REQUEST FOR INFORMATION	DATE: March 07, 2017	NO.: RFI-474
--------------------------------	-----------------------------	---------------------

Project Name:	15051-Webster University Interdisciplinary Science Building	Project No.: 15051
---------------	---	--------------------

Subject: Webster radius lintel flashing

LINTEL FLASHING PROFILE

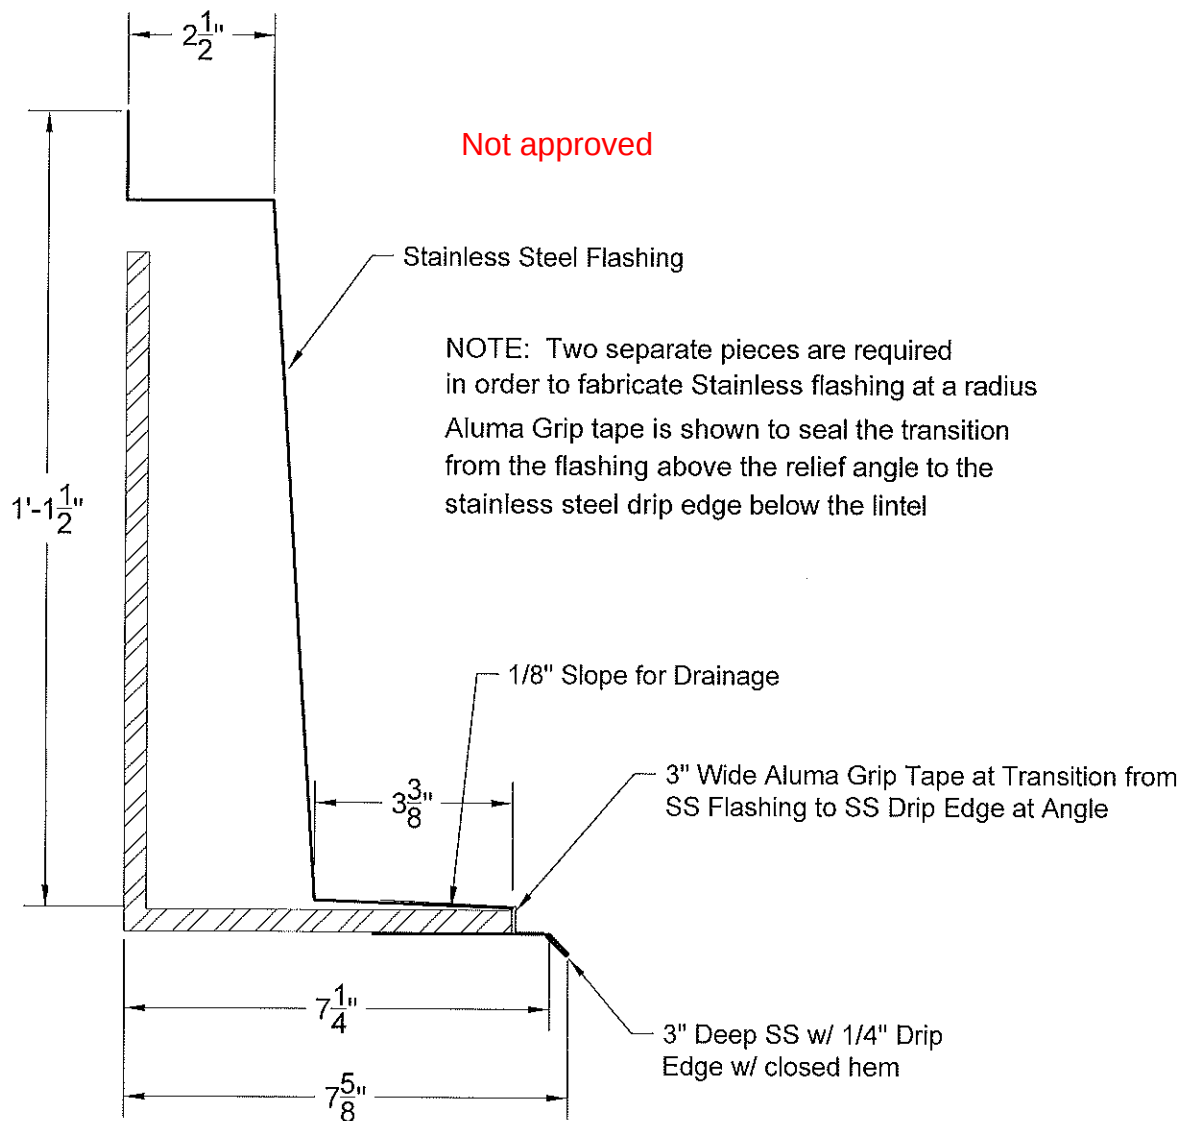
Hohmann and Barnard fabricated a 1 piece radius base flashing for the radius masonry mockup and communicated they could fabricate a 1 piece radius lintel flashing also. Hohmann and Barnard has now communicated they cannot make the 1 piece lintel flashing with the drop profile at the tip of the lintel because it's too small to solder together. A local fabricator was also contacted and they could not fabricate either for the same issue. Please advise if the attached 2 piece system would be acceptable with an alumina-grip connection, or a flexible stainless steel flashing connection could also be utilized.

Attached detail is not acceptable. Install 1'-0" long max. section per the on-site mock-up, solder all seams and reinforces with 3" min. seam tape each side of seam.
